SERVICE BULLETIN

SERVICE BULLETIN NO. 237

3040 KODAK RP X-OMAT Processor, Model M6B

Modification No. 4 for the Kodak RP X-Omat Processor, Model M6B

Removal and Replacement of the DRYER TRANSPORT PULLEY

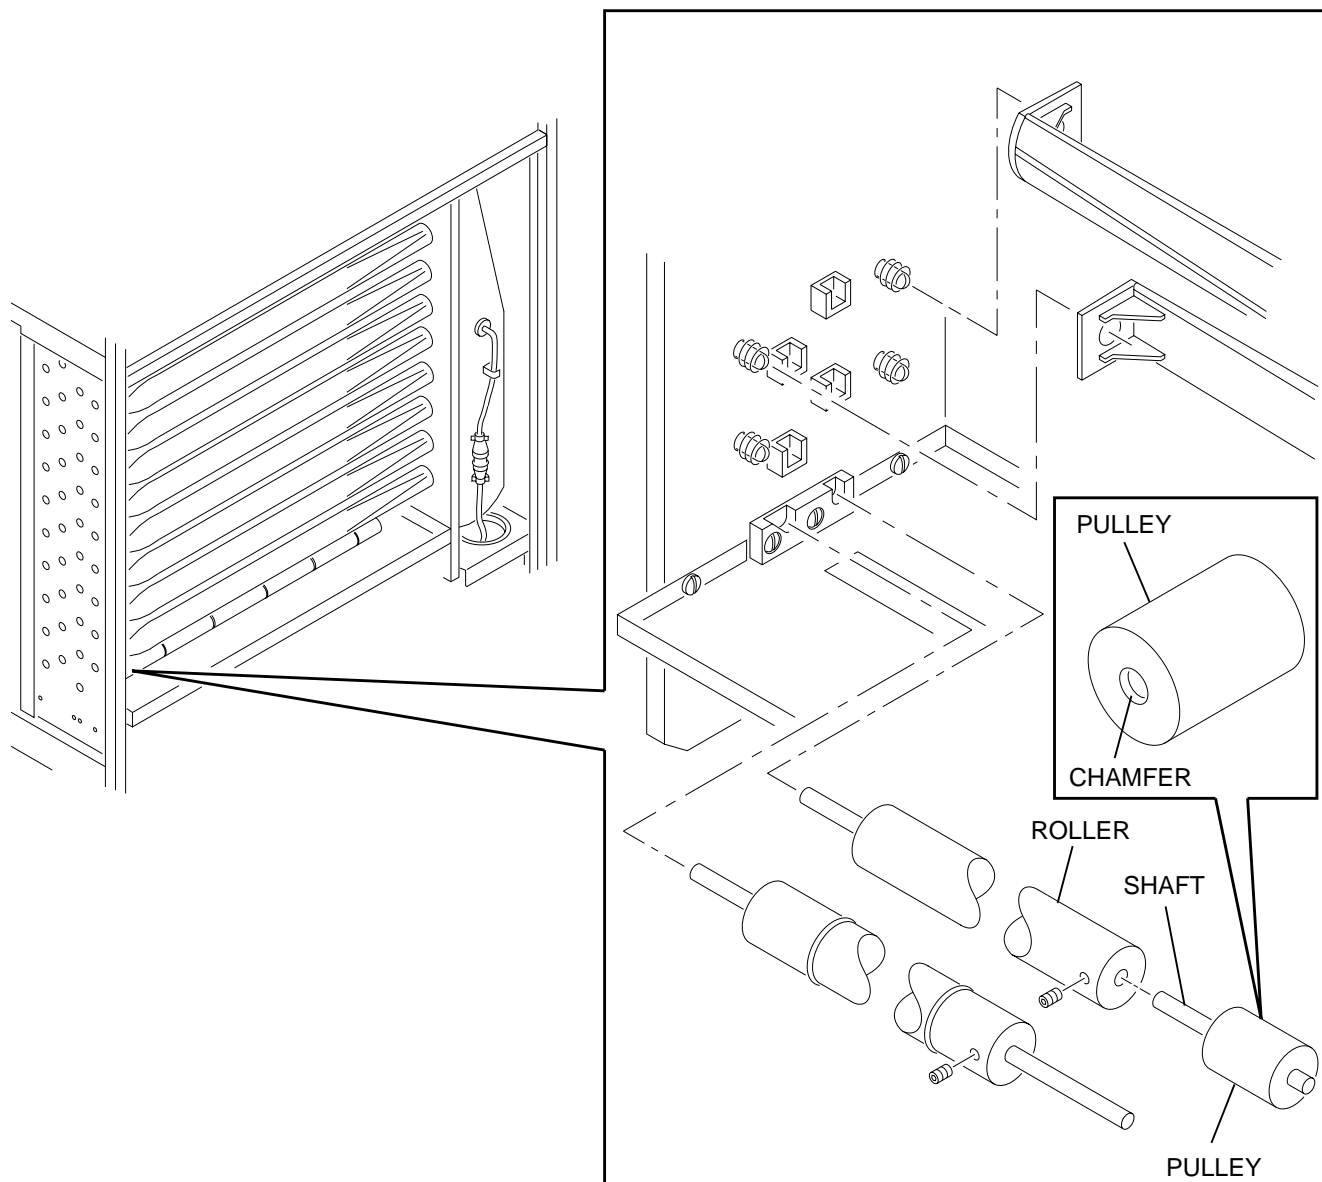
There have been a number of incidents reported where the DRYER TRANSPORT PULLEY fail by splitting shortly after being replaced. When replacing a PULLEY it is important to note which end has the CHAMFER on the hole for the SHAFT. It is also important to ensure that the CHAMFER faces toward the ROLLER when the PULLEY is installed on the SHAFT. The procedure for the Removal and Replacement of the DRYER TRANSPORT PULLEY, has been modified to reflect this change as follows:

- [1] Disconnect the main power.
- [2] Observe the position of the PULLEY on the SHAFT and remove the PULLEY.

- [3] Wet the new PULLEY with hot water.
- [4] Observe the position of the CHAMFER on the new PULLEY. Install the PULLEY with the CHAMFER toward the ROLLER.
- [5] Install the new PULLEY onto the SHAFT in the same position as observed in Step 2.
